RE: RESPONSE TO INFORMATION REQUEST IN RELATION TO THE DEVELOPMENT APPLICATION FOR A DEVELOPMENT PERMIT FOR THE MATERIAL CHANGE OF USE (MULTIPLE DWELLINGS AND SHORT TERM ACCOMMODATION), RECONFIGURATION OF A LOT 2 LOTS INTO 4 LOTS AND COMMON PROPERTY AND SERVICES EASEMENT) OVER LAND AT 9, 11 AND 13 DAVIDSON STREET, MOSSMAN, MORE FORMALLY DESCRIBED AS LOTS 612 AND 613 ON PTD2092 AND LOT 1 ON RP738379

COUNCIL REF: MCUC 2026_5907/1

On behalf of the Applicant, please accept this correspondence as the Applicant's full response to the above referenced Request for Information pursuant to s13.2(a) of the Development Assessment Rules v3.

EXTERNAL SEWERAGE 1:100

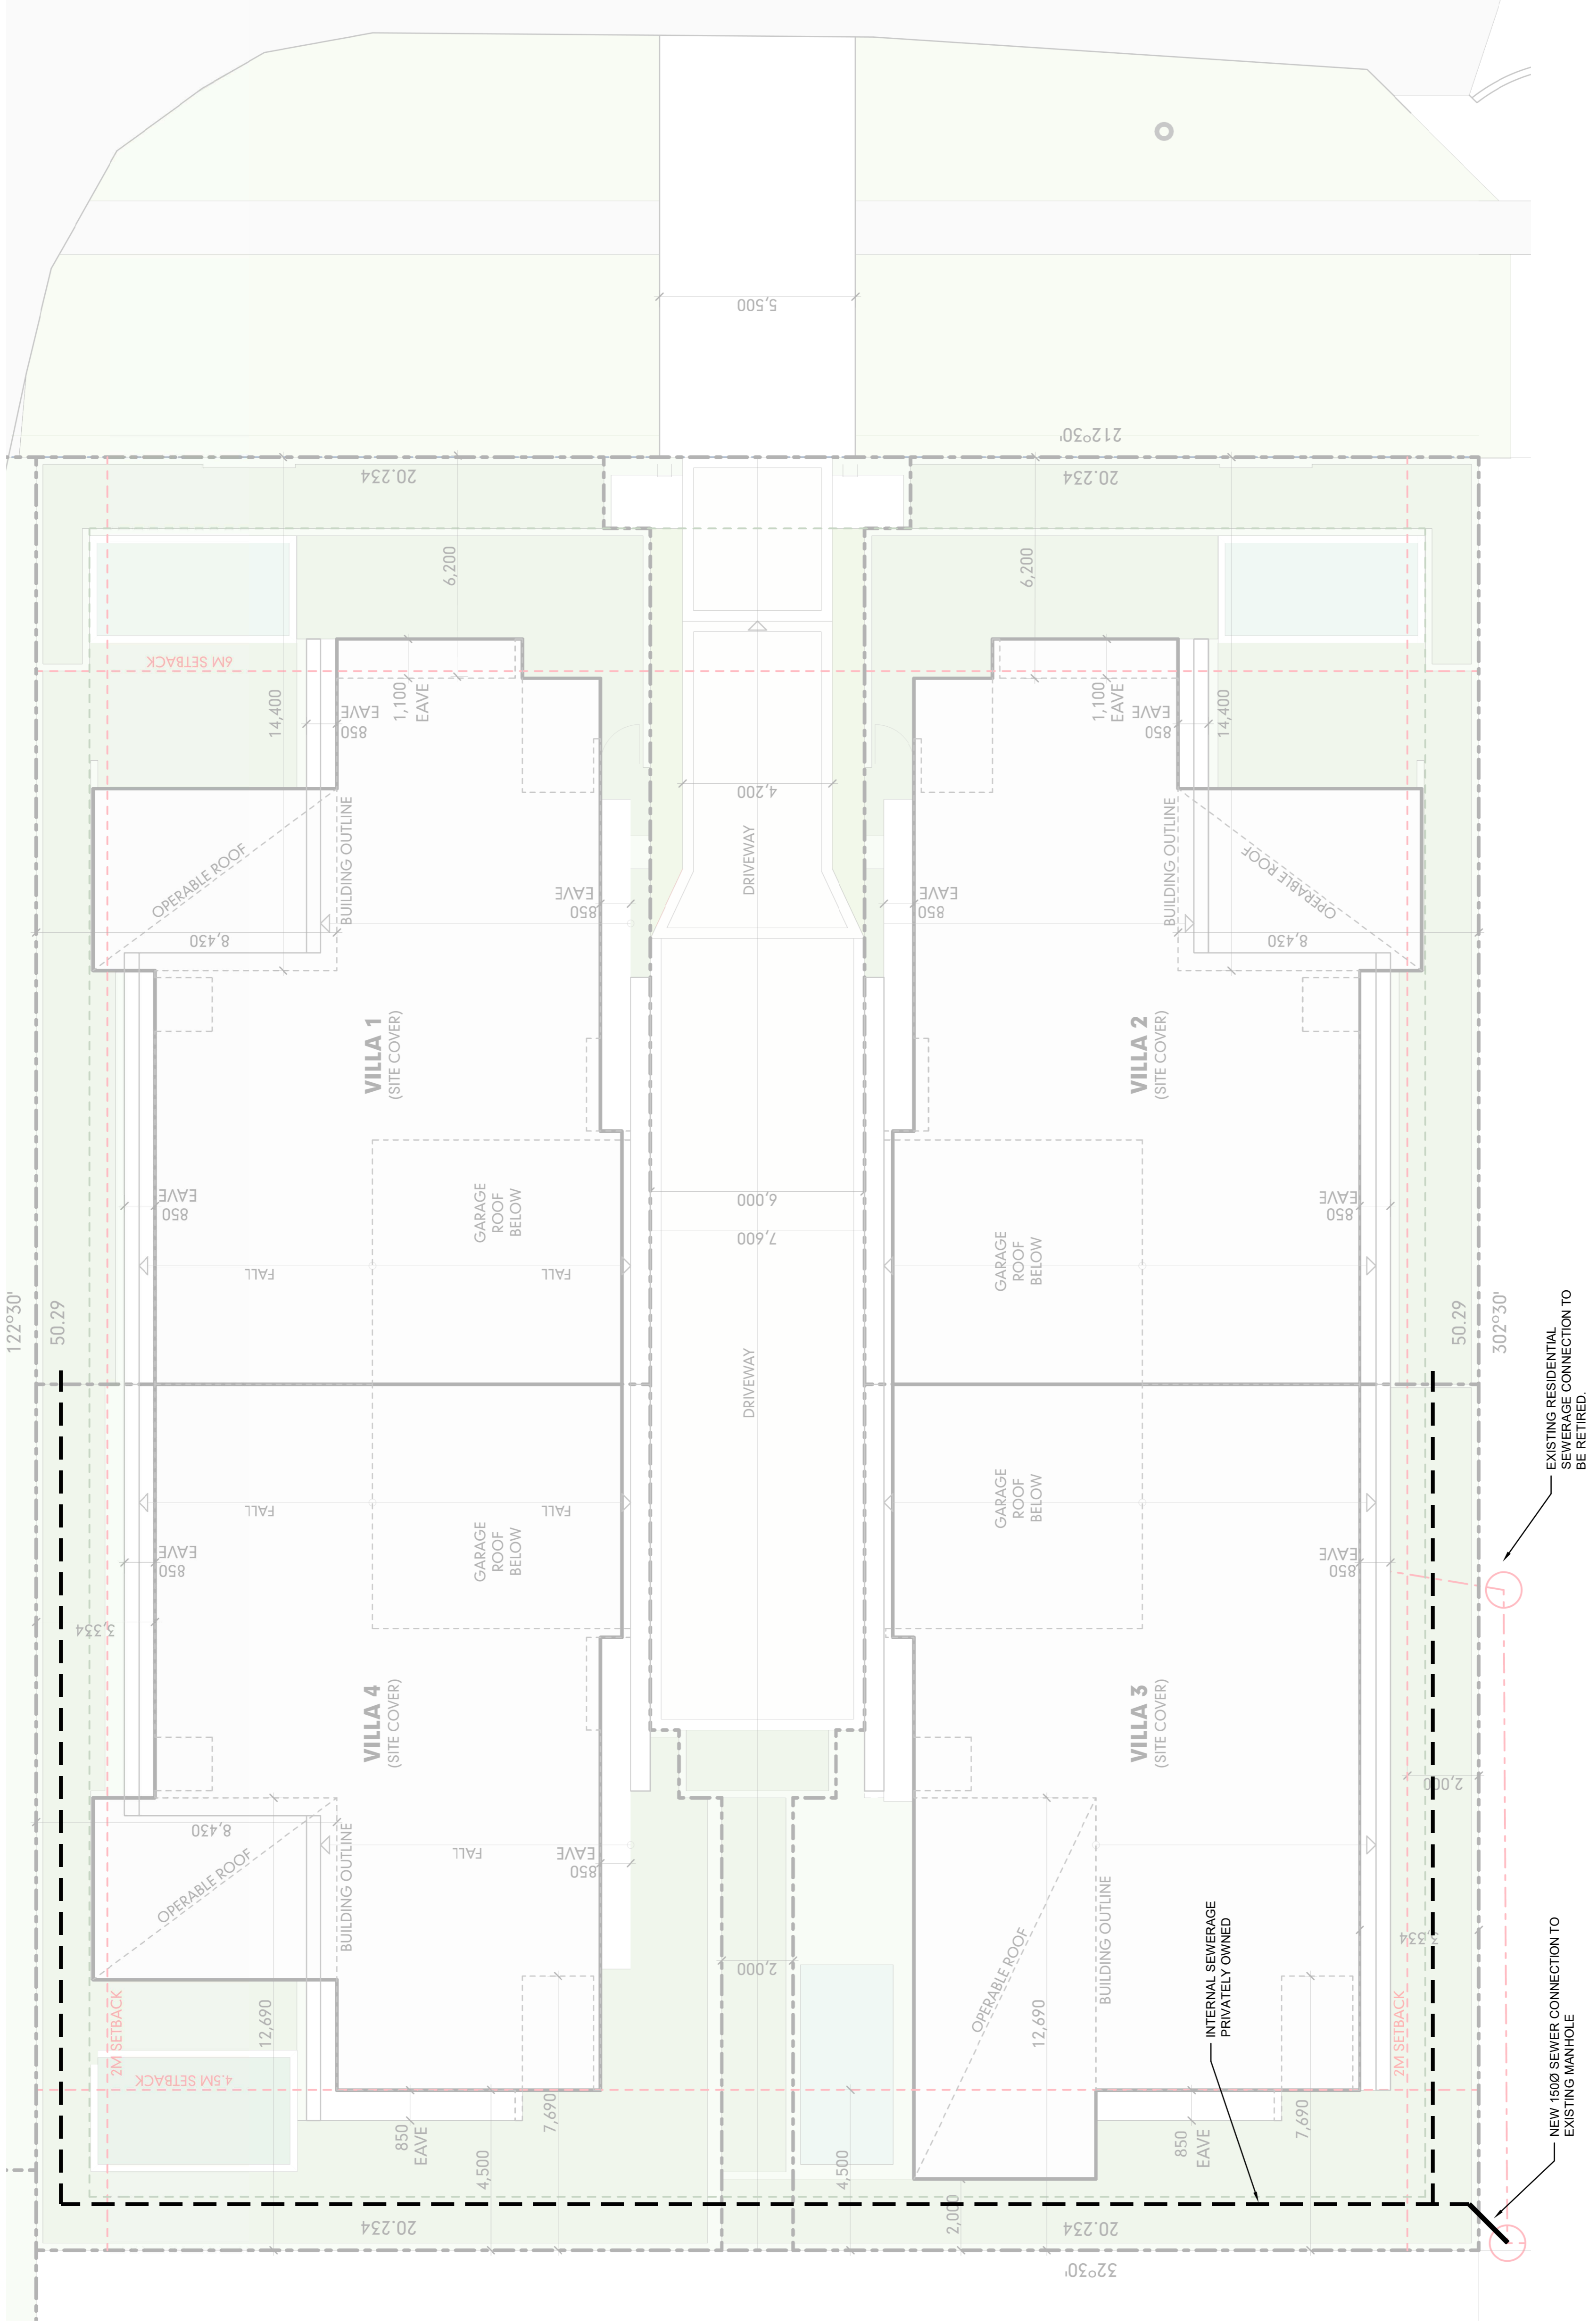
Information Request Item 1: Sewer Design Plan

Please provide a civil design plan for the proposed sewer servicing for the units and the design for the reconfiguration, including the nomination of any common property for this service.

It is proposed to rationalise the existing sewerage infrastructure servicing the site by removing a portion of the existing residential sewer connection and providing a new consolidated connection point for the reconfigured lots.

Specifically, the existing residential sewerage connection is proposed to be decommissioned, with all four proposed lots to be connected via a new 150mm diameter sewer line to the existing Council manhole located adjacent to the south-western corner of the site. This approach provides a single, efficient point of connection to the reticulated network and avoids the need for multiple individual connections.

The proposed internal sewerage network will be privately owned and maintained, servicing each of the proposed lots via a coordinated internal layout. The configuration has been designed to align with the proposed building envelopes and driveway arrangement, ensuring practical and efficient servicing outcomes across the development.

The internal sewer infrastructure is intended to be located within areas that will be designated and protected through easements, thereby ensuring ongoing access for maintenance and management purposes without encumbering individual lots.

The proposed design is illustrated in the External Sewerage Plan prepared by KFB Engineers (Drawing No. K-I5080-C01, Revision P1), included as Attachment I. The plan clearly identifies:

- The removal of the existing residential sewer connection;
- The new 150mm sewer connection to the existing manhole; and
- The layout of the internal, privately owned sewerage infrastructure servicing the development
